ALPINE CITY PLANNING COMMISSION MEETING

SUBJECT: Site Plan Review – Bank of American Fork

Re: Site Plan Review – Bank of American Fork
Applicant: Jason Sandburg, representing People’s Intermountain Bank
Project Location: 105 S. Main Street
Zoning: Business Commercial Zone
Acreage: Approximately 0.84 Acres
Building Area: 4,166 Sq. Ft.
Request: Recommend approval of the site plan

Re: *Bank of American Fork – Site Plan Review 105 S Main*

Proposed Site Plan

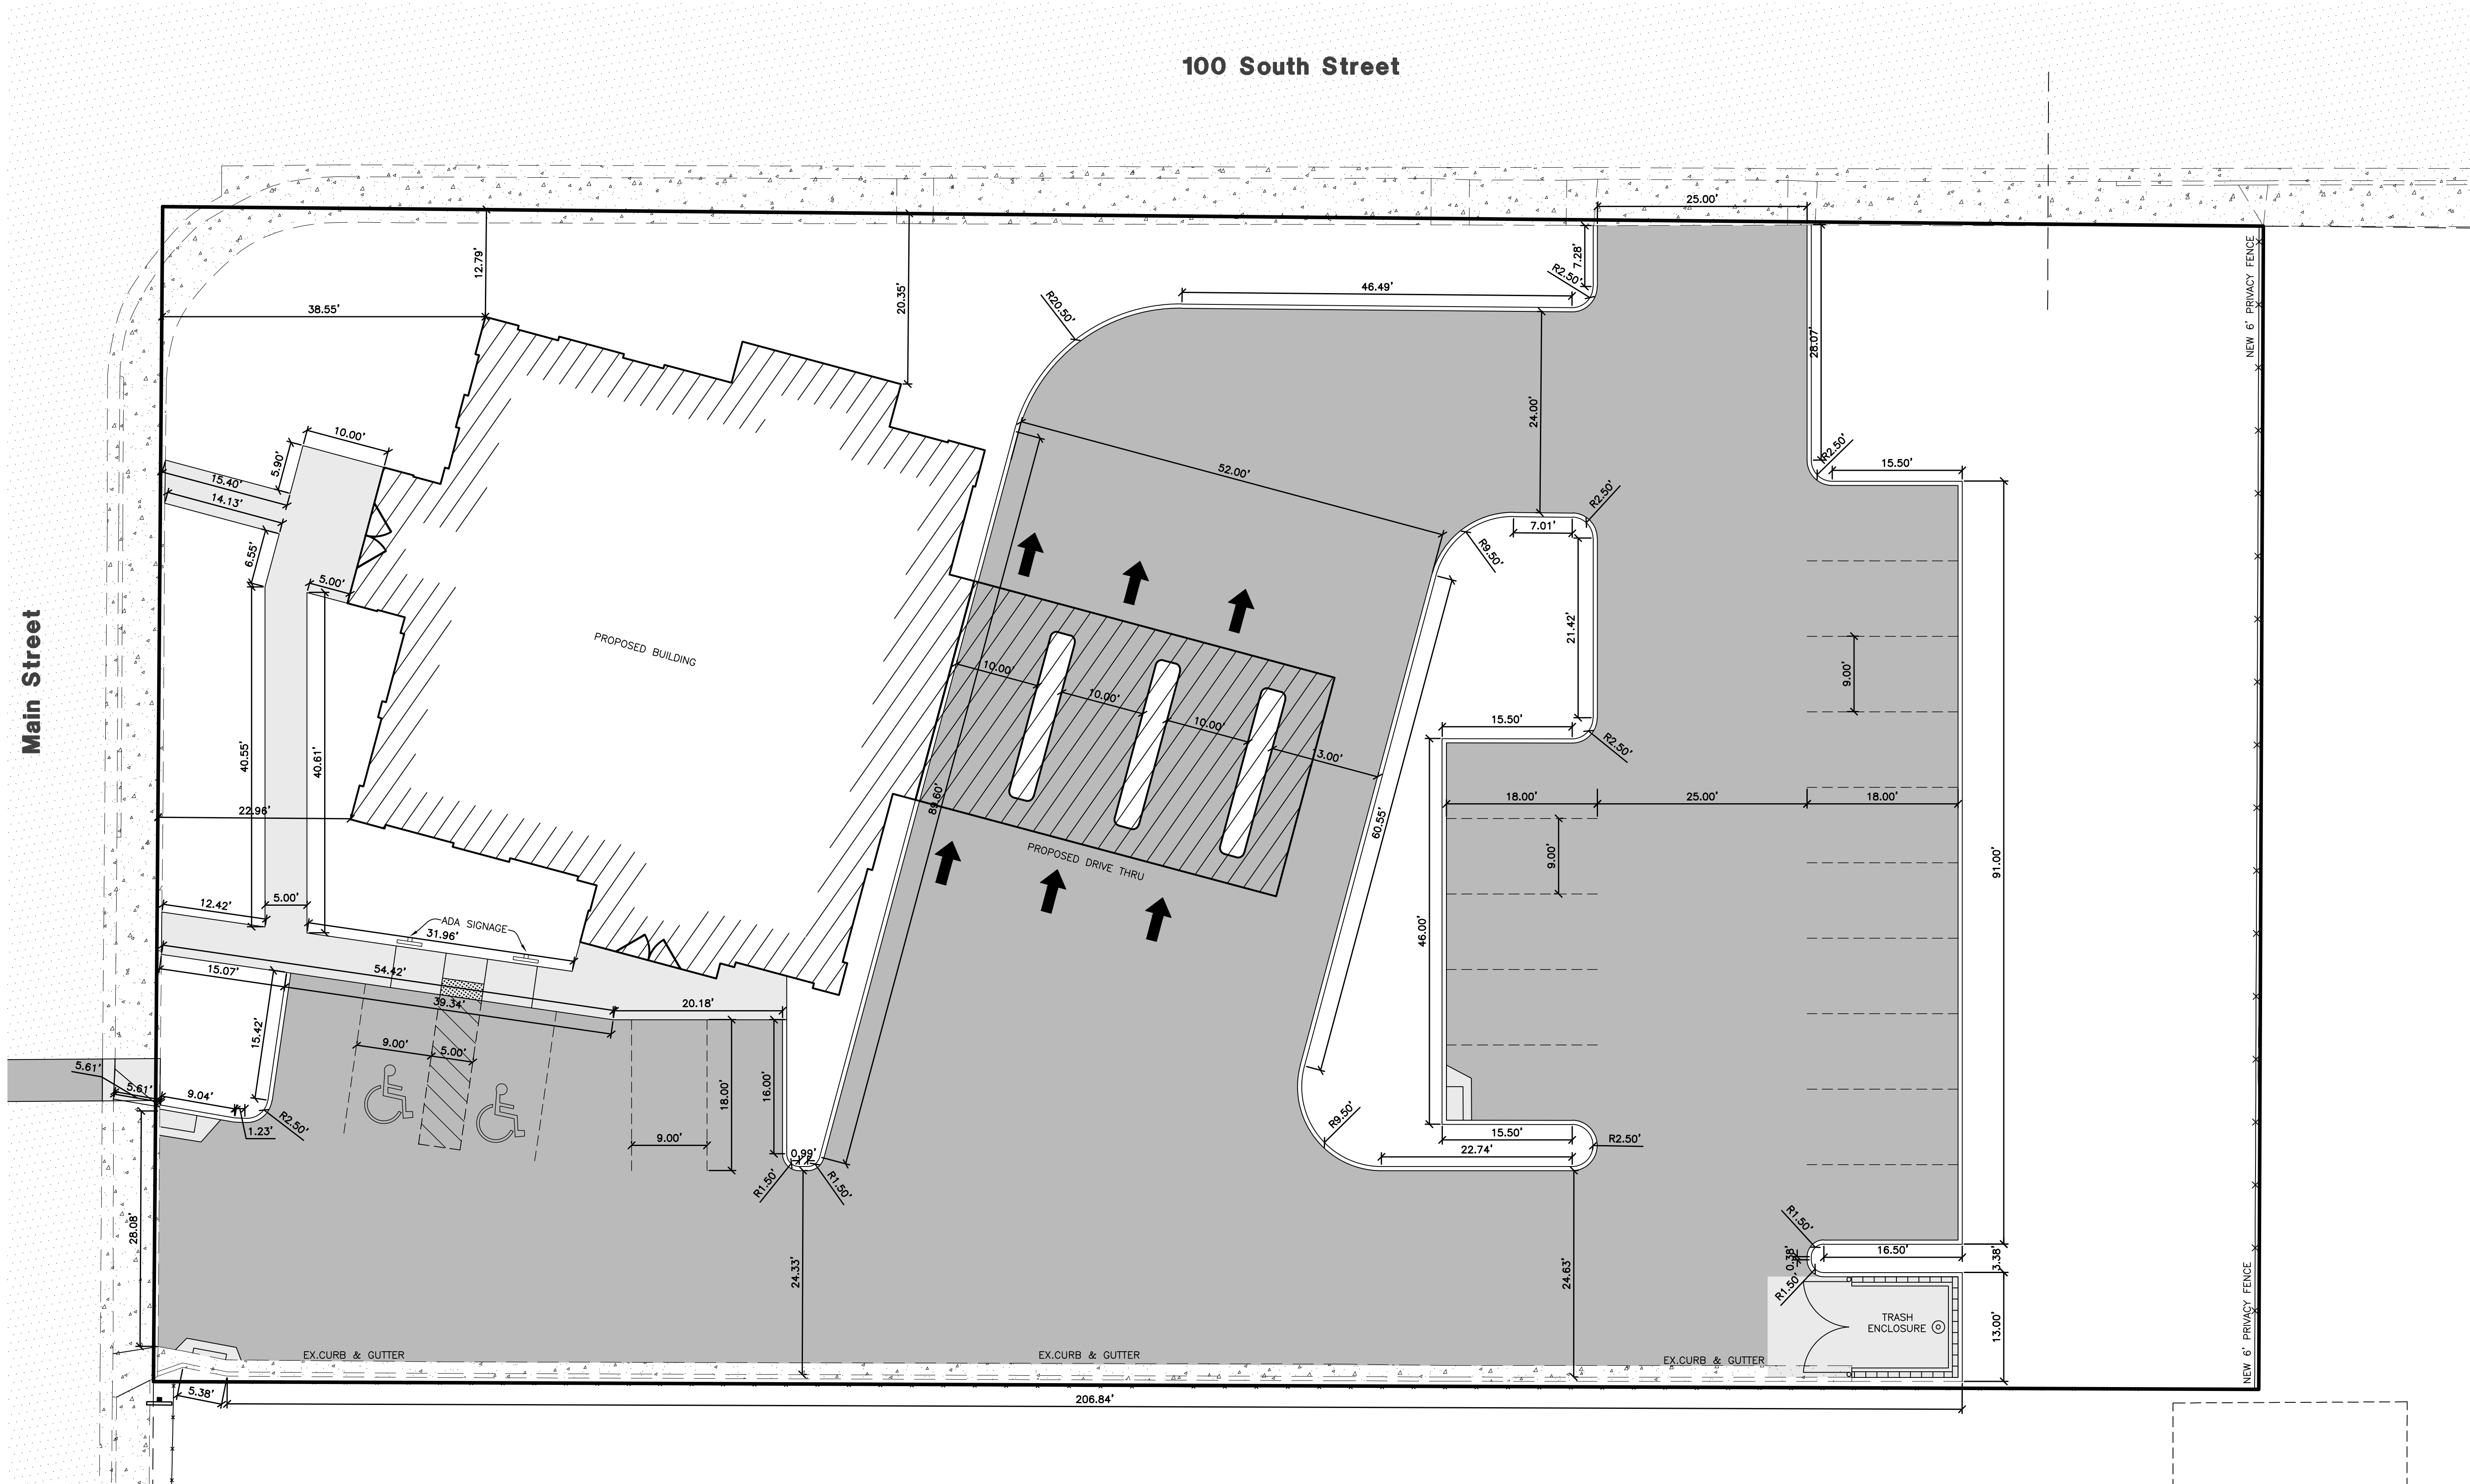
Setbacks (3.07) for the building were approved by the City Council on October 23, 2018, with an exception being granted. The approved setbacks are: 10'2" on the north and 20'10" on the west as measured one foot behind the sidewalk. The City Council also approved three parking spaces to be allowed in the setback. The site plan presented honors the exceptions granted by City Council.

Plans show that visibility within the sight triangle (3.25) is improved with the new site plan. Also improved is access off 100 South, which improves safety associated with the drive-through lanes. The proposed 100 South access is located further east on the property which improves safety and traffic for the intersection of 100 South and Main Street.

City code requires (3.24.030) offices and personal services to have four (4) spaces for every 1,000 sq. ft. based on the square footage of the proposed building (4,166 sq. ft.) 17 off-street parking spaces are required. The proposal exceeds the off-street parking requirements, with plans showing 19 parking stalls plus two (2) ADA stalls for a total of 21 parking stalls.

"The sides and rear of any off-street parking area that adjoins a residence or residential zone shall be required to be screened by a masonry wall or solid visual barrier fence" (3.24.020). Plans show a 6-foot privacy fence on the east property line which meet these requirements, however **a fence or other solid visual barrier is required for the south property line.**

- The developer obtain a Demolition and Land Disturbance Permit prior to construction.
- Screening be added to the parking lot on the south property line.

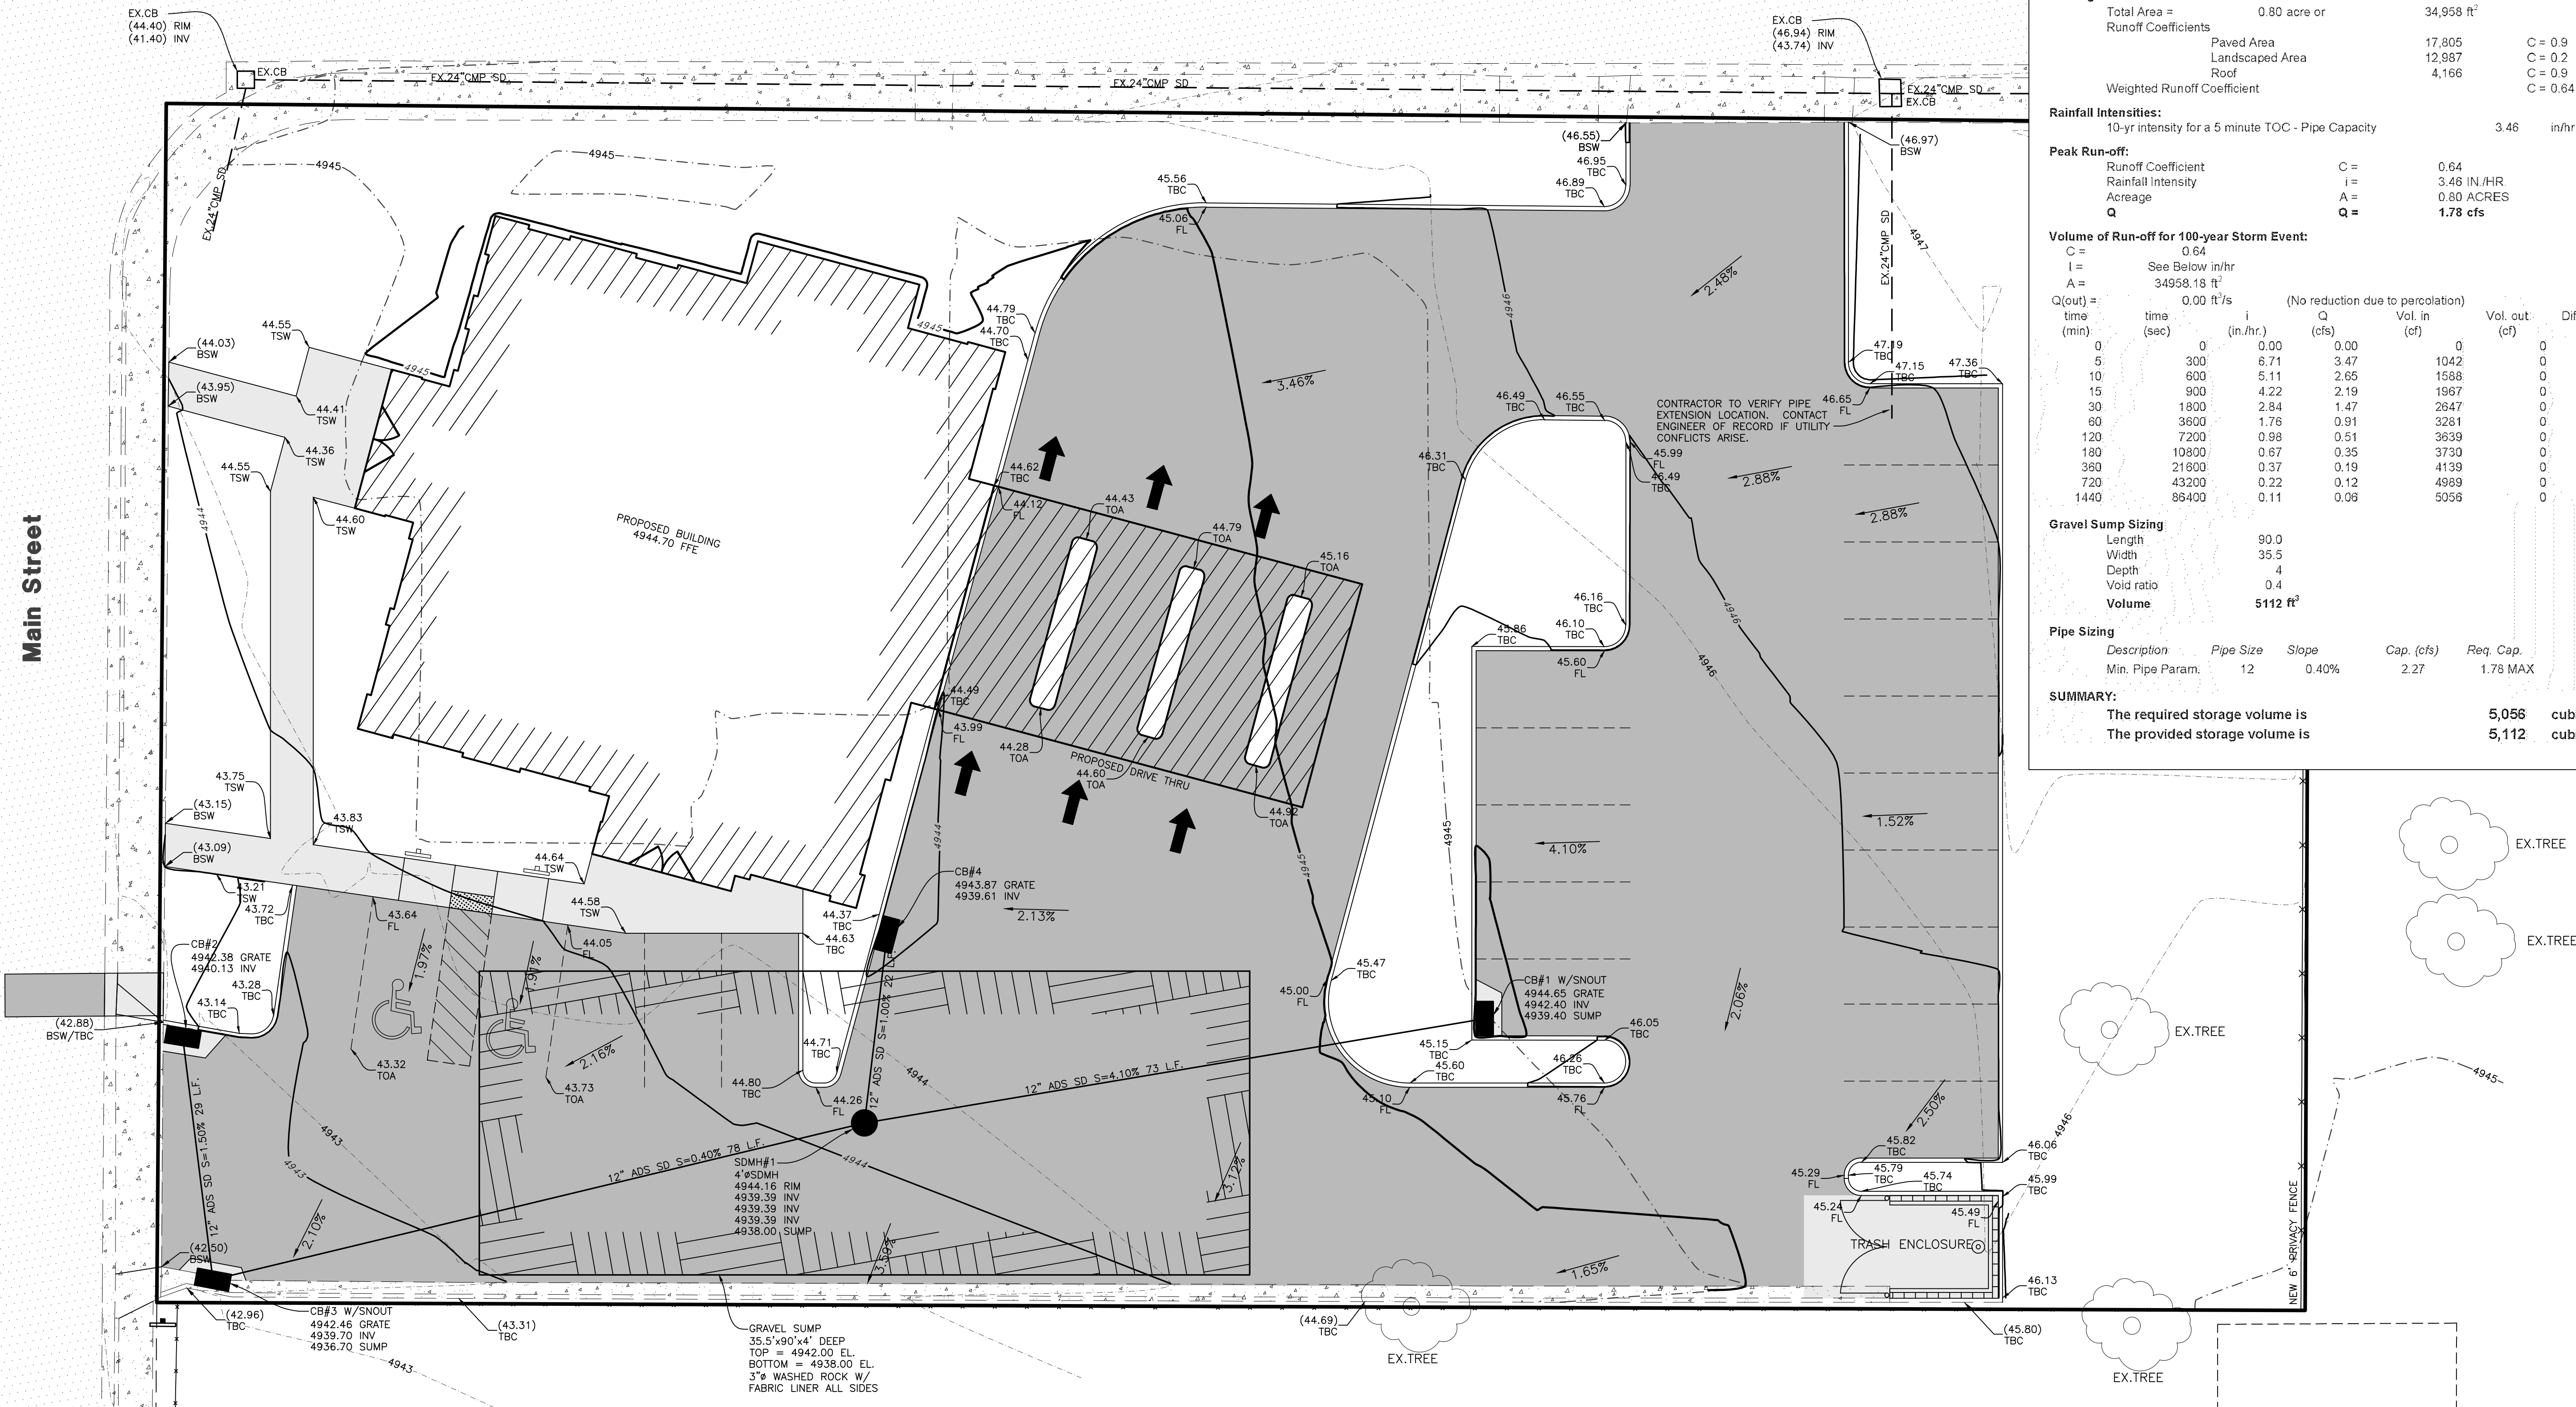
Two buildings exist on the site. The easterly building will be removed and NOT replaced. The existing City utility services (culinary, pressurized irrigation, and sewer) shall be removed and capped as shown on the plans. The bank building will be rebuilt in approximately the same location and will be able to re-use the existing services.
